# PEERLESS FARMS CONSTRUCTION DOCUMENTS

PEERLESS FARMS  
EL PASO COUNTY, COLORADO  
COVER SHEET  
CONSTRUCTION DOCUMENTS

PEERLESS FARMS  
EL PASO COUNTY, COLORADO  
NOTES & DETAILS  
CONSTRUCTION DOCUMENTS

PROJECT NO.  
196114000  
DRAWING NAME  
196114000\_CV.dwg  
C2.1

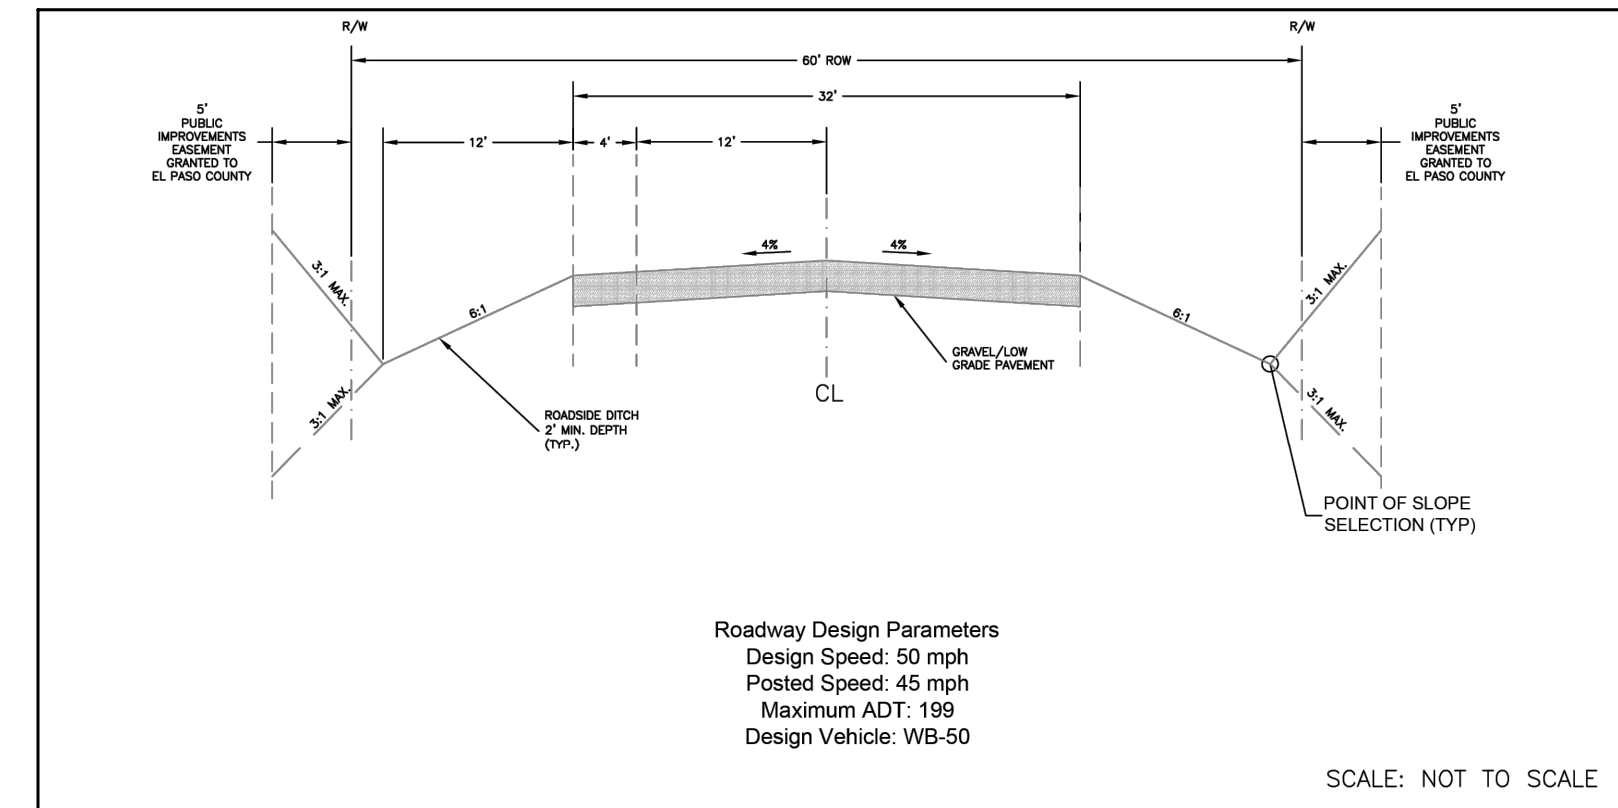
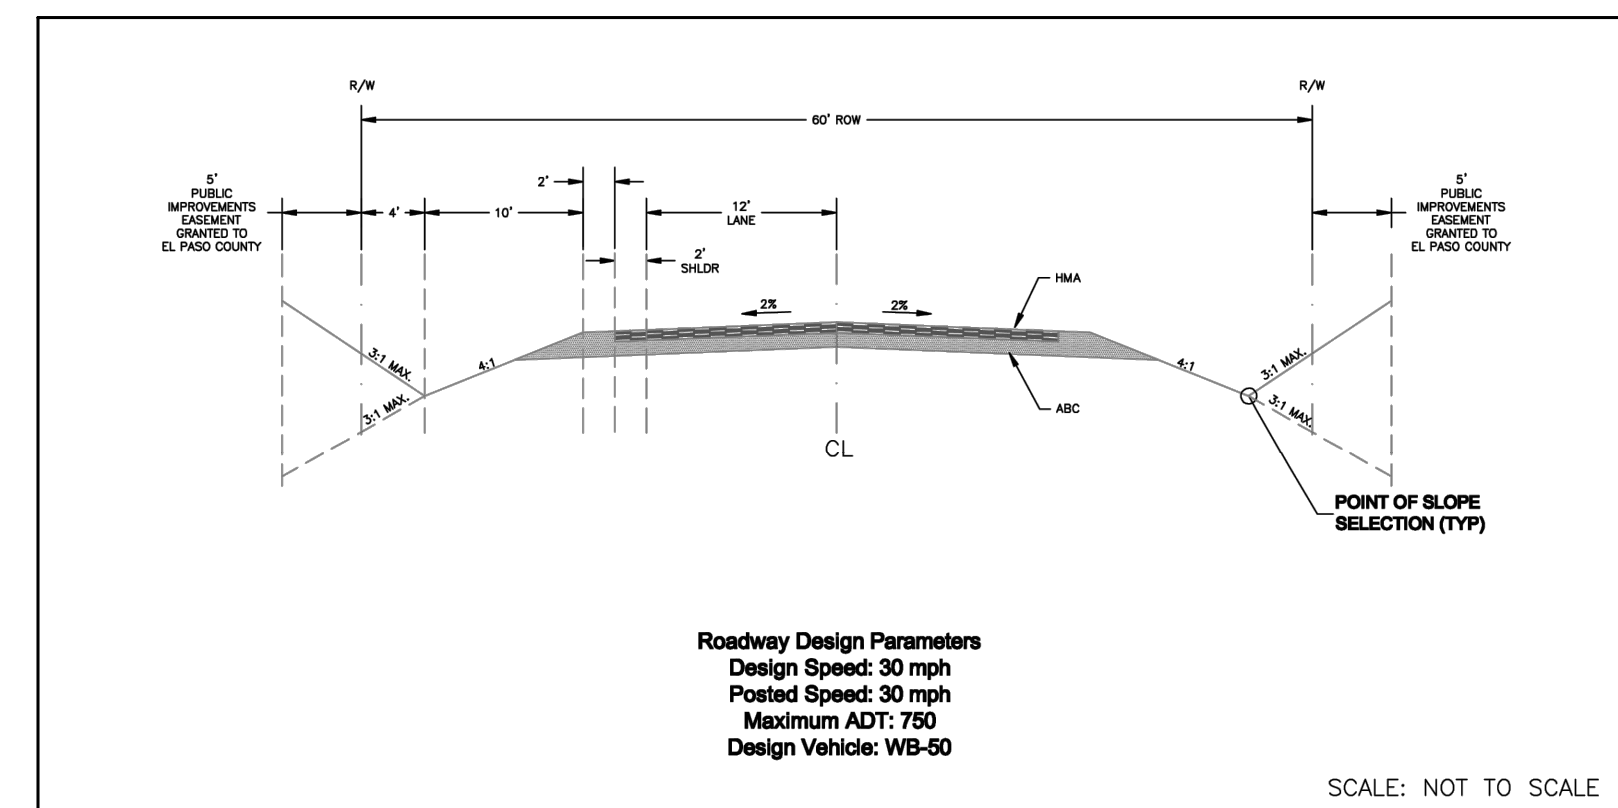
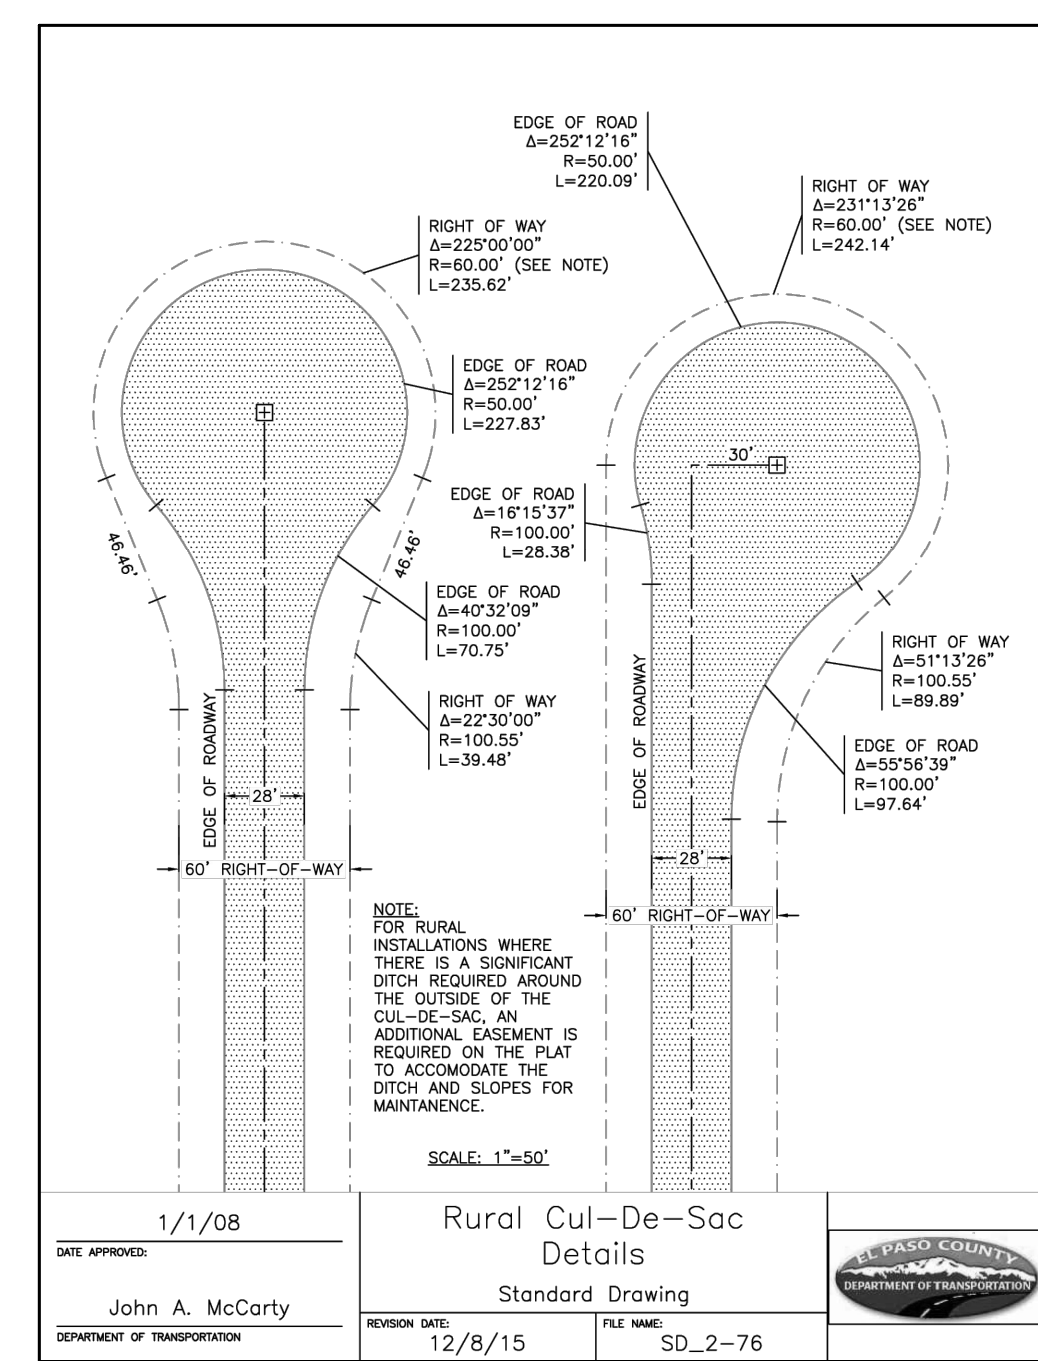
Unresolved from Submittal 1: Provide a detail of drainage ditch cross section with side slopes, min depth, etc.

Submittal 2 addition: The detail on sheet two shows two different cross sections, one that is not applicable if appears since the slopes are 4:1 and only one has a min depth listed. It needs to be clear the proposed side slopes (both front and back) and min depth for the construction of these ditches since they are providing drainage and water quality.
